CITY OF CODY
PLANNING, ZONING AND ADJUSTMENT BOARD
TUESDAY, JANUARY 8, 2013
CITY HALL COUNCIL CHAMBERS @ 12:00 NOON

**CITY OF CODY
PLANNING, ZONING AND ADJUSTMENT BOARD
STAFF REPORT**

MEETING DATE:	JANUARY 8, 2013	TYPE OF ACTION NEEDED	
AGENDA ITEM:		P&Z BOARD APPROVAL:	X
SUBJECT:	AMENDED SITE PLAN REVIEW: WYOMING AUTHENTIC PRODUCTS (MEAT PROCESSING) SPR 2013-04	RECOMMENDATION TO COUNCIL:	
PREPARED BY:	TODD STOWELL, CITY PLANNER	DISCUSSION ONLY:

1
C1.1 **SITE AND UTILITY PLAN**

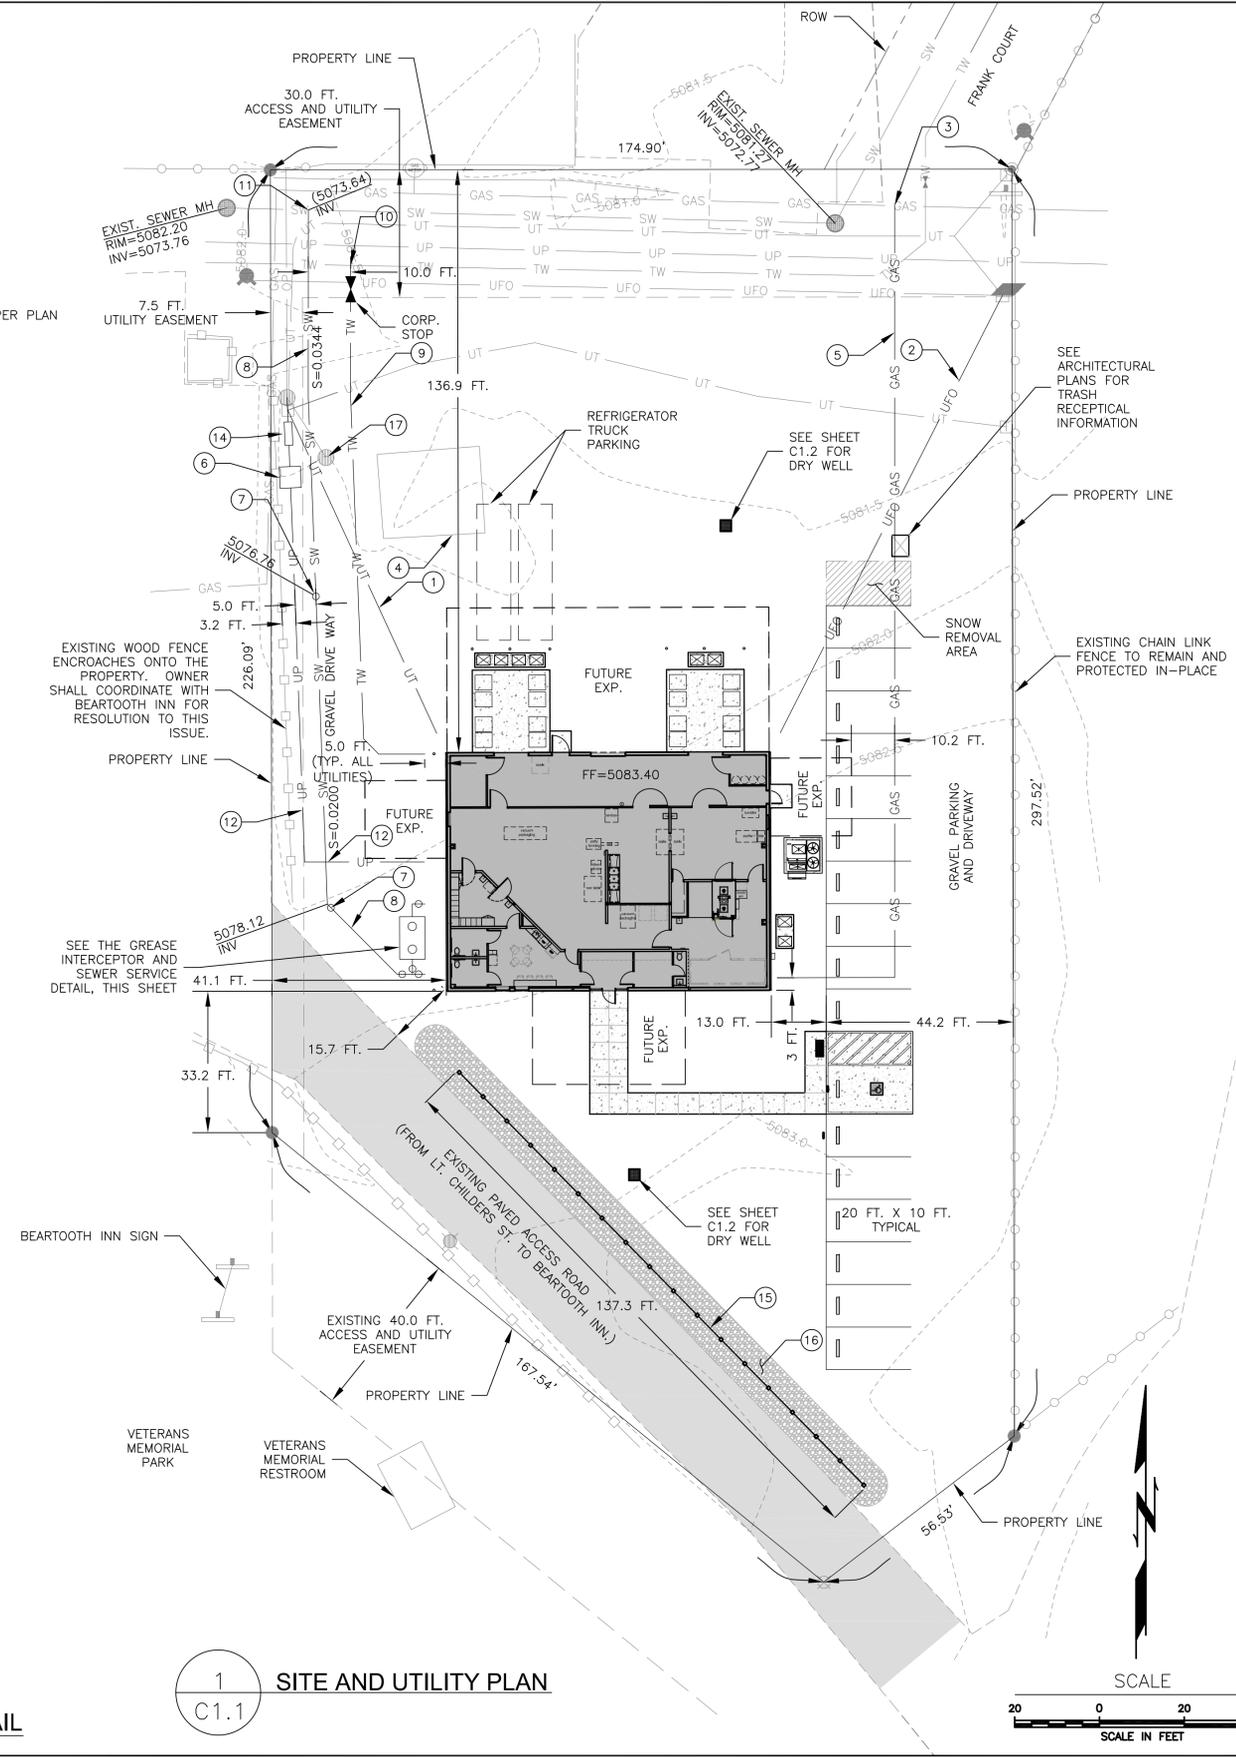
The details for the ADA parking and access are mostly provided, but lack grade information. Additional detail will be needed with the building permit.

The city does not have current fire flow data for the fire hydrants closest to this facility. Fire flow will need to be tested and verified with the Fire Marshal.

1. Provide additional ADA details as needed for the building permit.
2. All storm water facilities are to be inspected and certified by the applicant's engineer prior to a certificate of occupancy.
3. If landscaping will not be installed prior to occupancy of the building, provide a financial surety prior to occupancy for its installation.
4. All exterior lighting must be of a downward/cutoff style and illumination levels modest in intensity.
5. The project must otherwise comply with the submitted site plan and applicable building, fire, and electrical codes. A building permit application is required.
6. (Any additional landscaping/irrigation specified by the Board.)
7. (Any architectural requirements specified by the Board.)

2 SOUTH ELEVATION
A3.1 SCALE 1/8" = 1'-0"

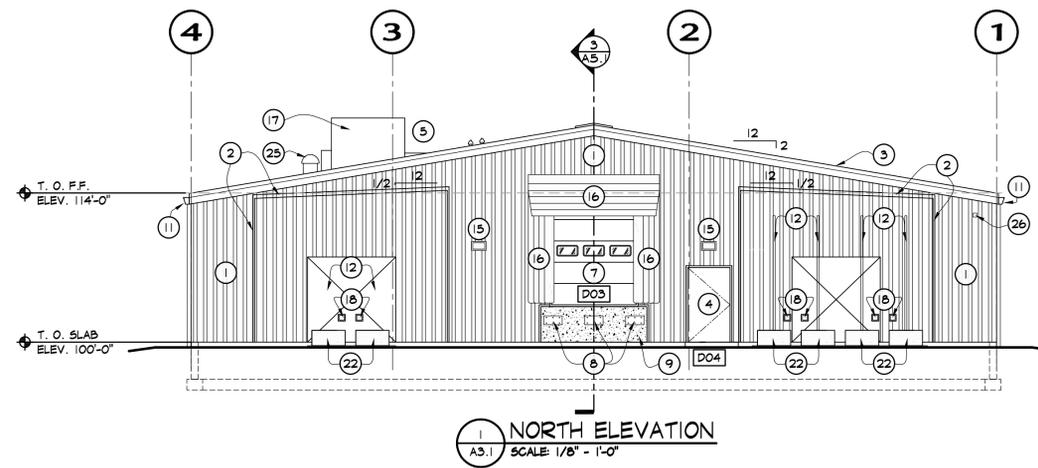
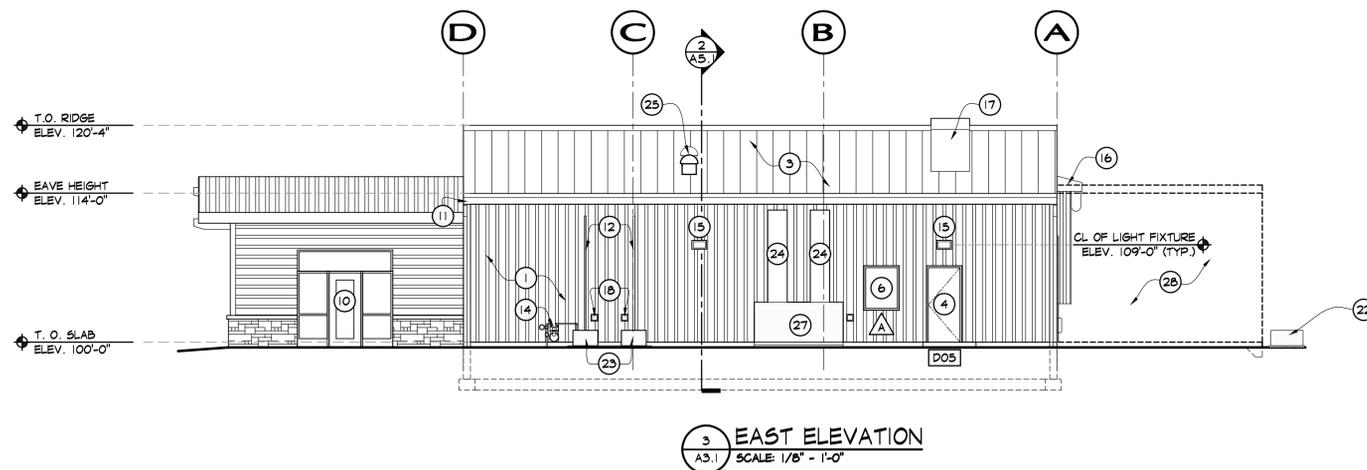
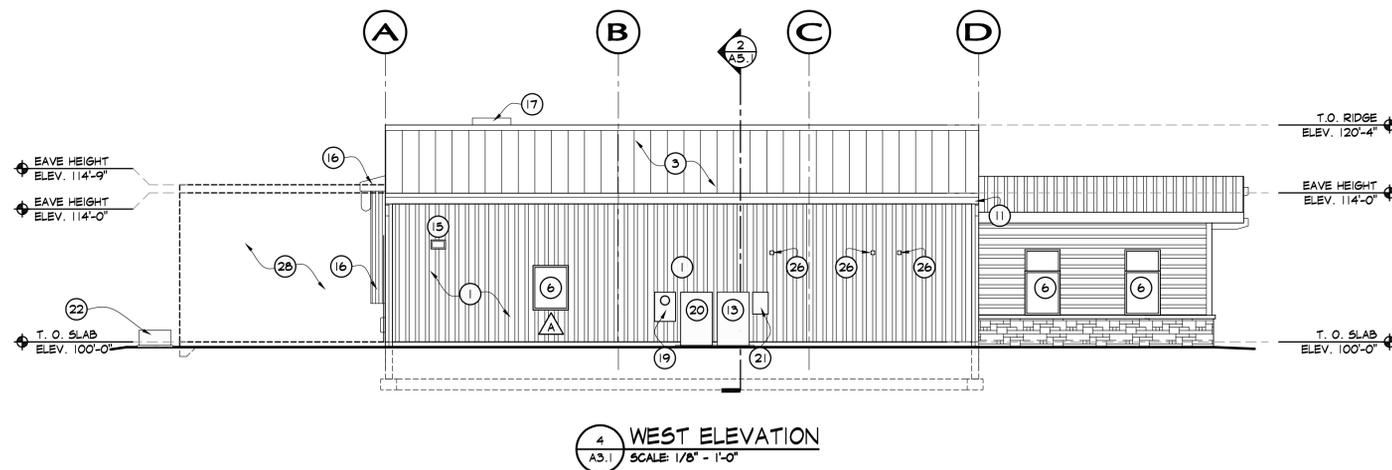
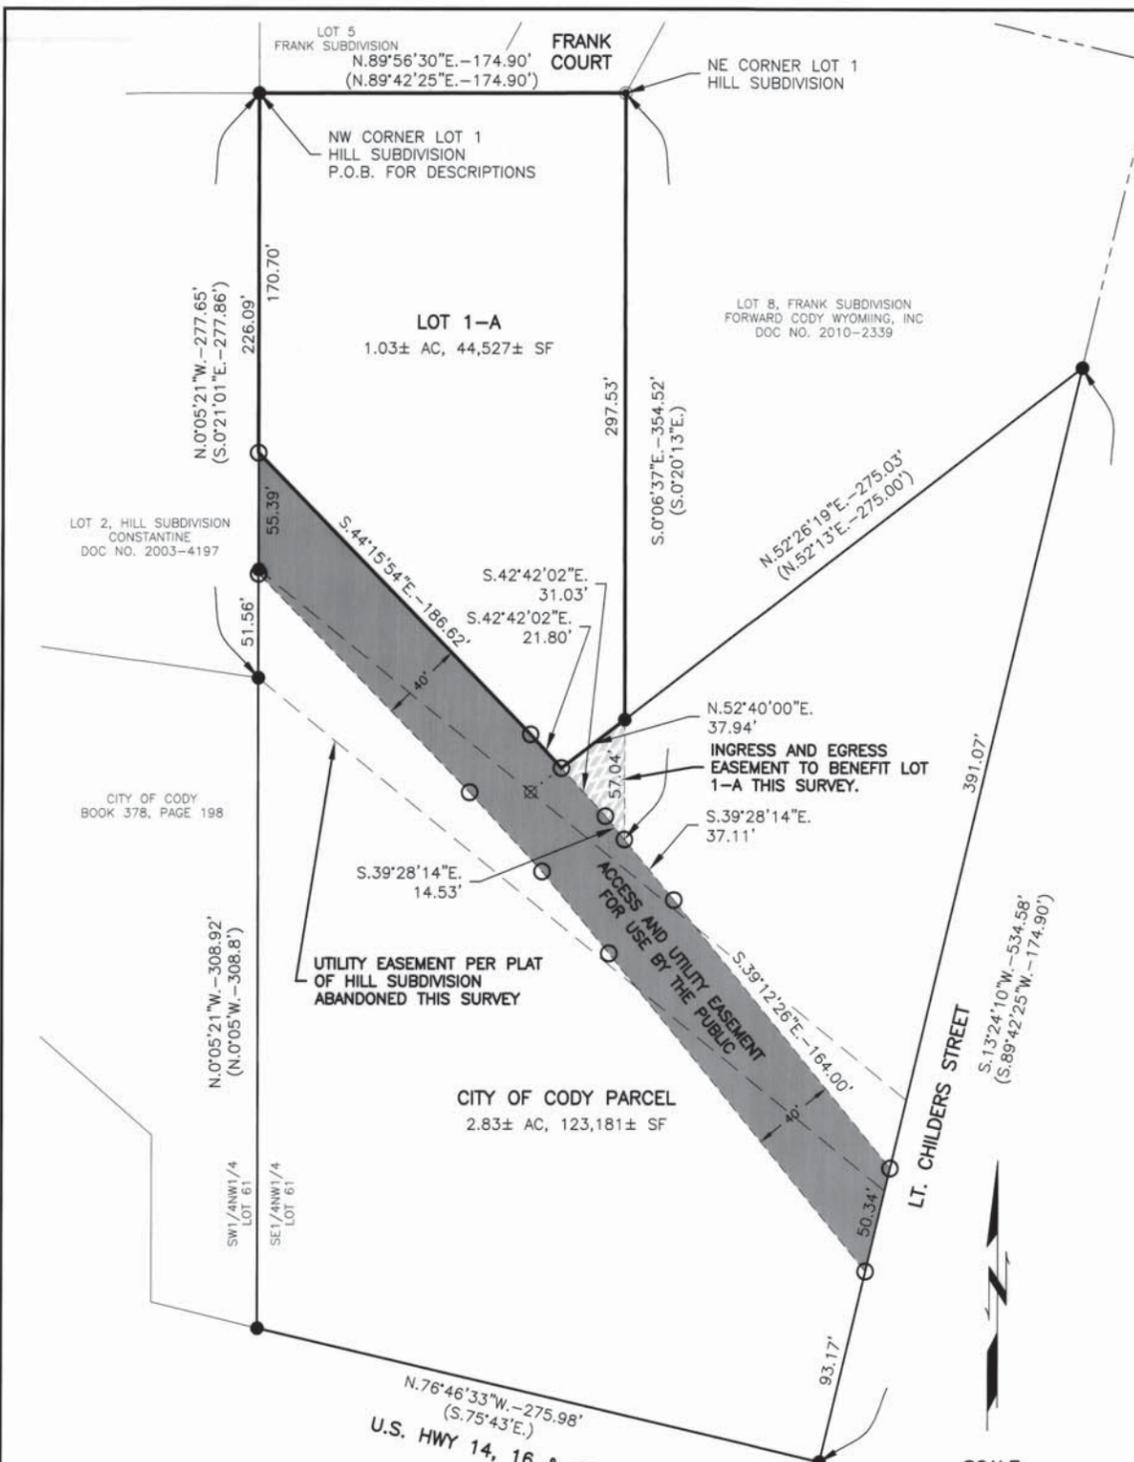
The architectural renderings are included in the application. The main building is proposed to be sided and roofed in sheet metal, and the office area will have horizontal

siding and a masonry wainscoting. The specific colors are not indicated in the application, but are shown as green siding and brown rock and trim on the architectural rendering. The wall height of the building is fourteen feet, (was 22'), with the peak approximately 20'4" (was 29').

The P&Z Board will need to determine if the proposed materials and colors of the Wyoming Authentic Products building are suitable.

A sign, as depicted on the architectural rendering, can be authorized at this time, although the applicant should clarify how the sign is lit. Any additional signage will need future review and approval.
